**TB 129**

## **TECHNICAL BULLETIN**

**Product:** Maxilift Hydraulic models

**Subject:** Emergency manual lowering valve (VSMA)

Exploded assembly of emergency manual lowering valve (VSMA)

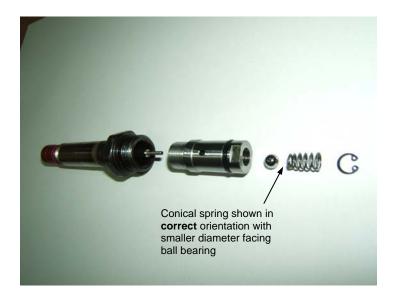
The issue relates to the emergency manual lowering valve on the NGV and NGV-A3 electronic valve block supplied by GMV. There have been 4 separate instances where the conical spring, which acts on the ball bearing to close the valve, has been assembled the wrong way round. This can result in the ball bearing becoming lodged inside the spring after using the manual lowering button to relieve the high pressure when undertaking a 200% pressure test or pressure relief test. As a consequence, the valve will be jammed in the open position and the lift will continue to descend at slow speed when the button is released.

If the above fault does occur during testing of the lift then the manual lowering valve must be disassembled and the spring reoriented to its correct position or the complete valve replaced.
